CHANGE ORDER

Project Name: **Haverhill Consentino Middle School** CO No. **10**

Architect's Project No. **21-0818**

CCD / PR / PCO #	Description	Amount
PCO 064	Controls Mounting Height	\$ 6,715.17
PCO 066	PR-12R1 RFI 57 Duct Chase	\$15,993.95
PCO 073	Music Storage Cabinet Doors	\$13,225.78
PCO 076	PR-47 RFI 183 Rated Horizontal Assembly	\$7,958.60
PCO 078	Modified Window Trim	\$25,390.41
PCO 081	Multivista Construction	\$29,077.65
PCO 083	Set Second Utility Pole	\$4,950.16
Total		\$103,311.72

SECTION DETAIL - HORIZONTAL ASSEMBLY AT SHAFT

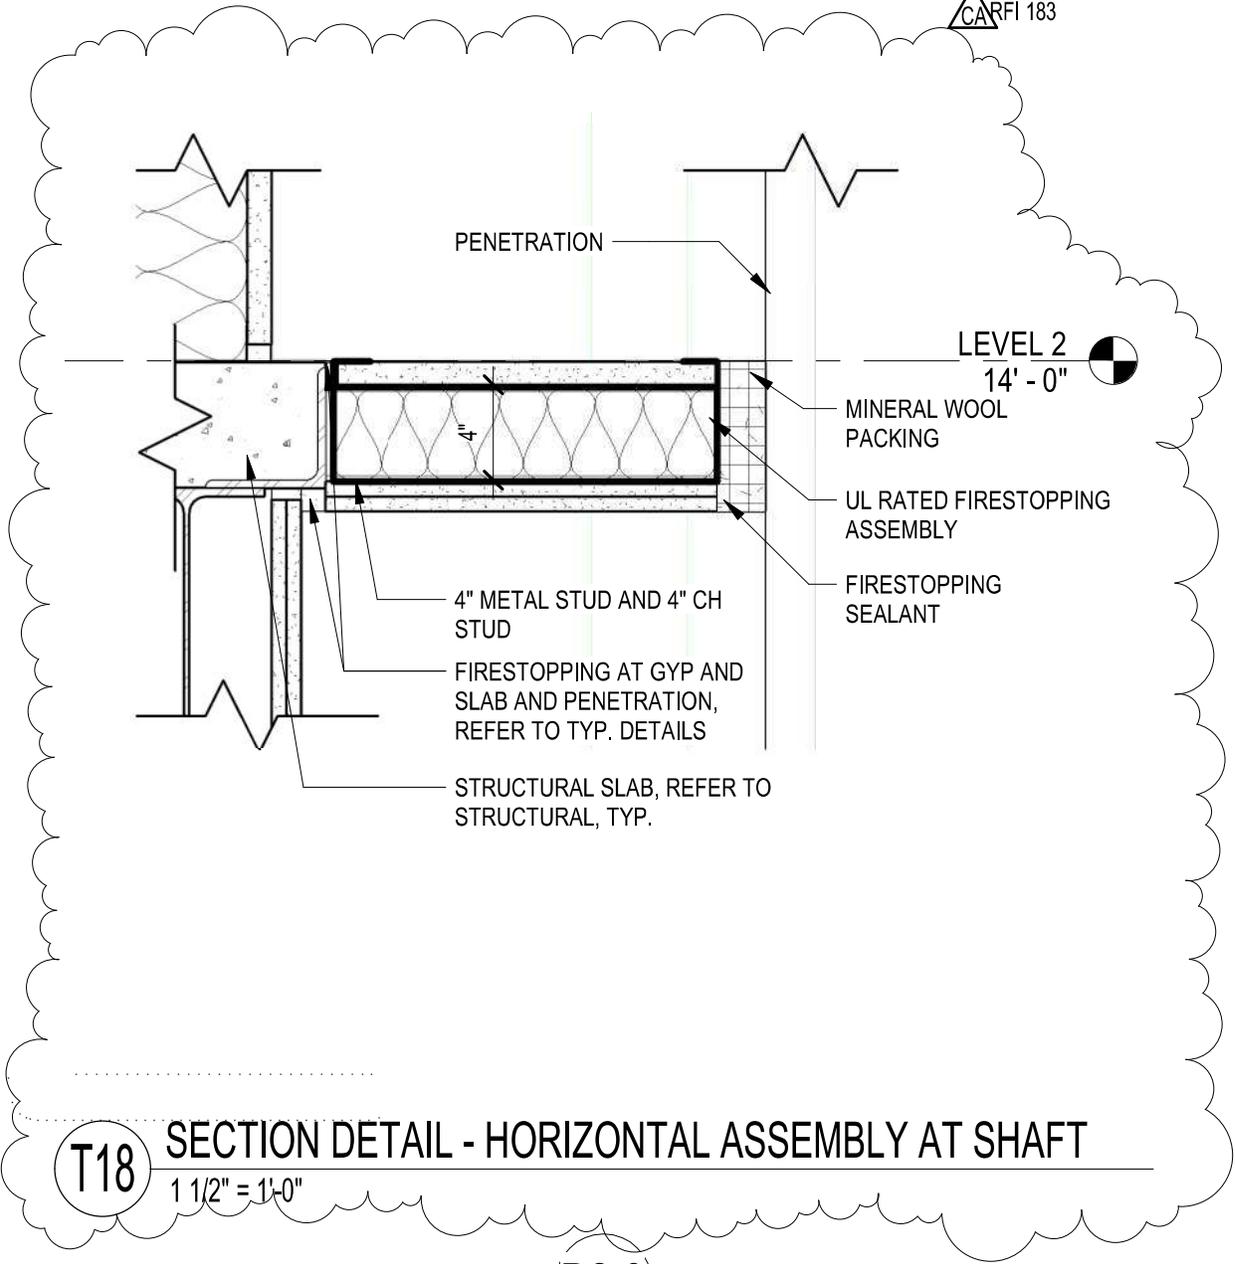
On Level 1 Area A and B, at Level 2 slab and ducts at shafts (Plumbing Storage rooms, 1081, 1101, 1119), provide 2hr horizontal assembly as shown on attached sketch **JD-91**.
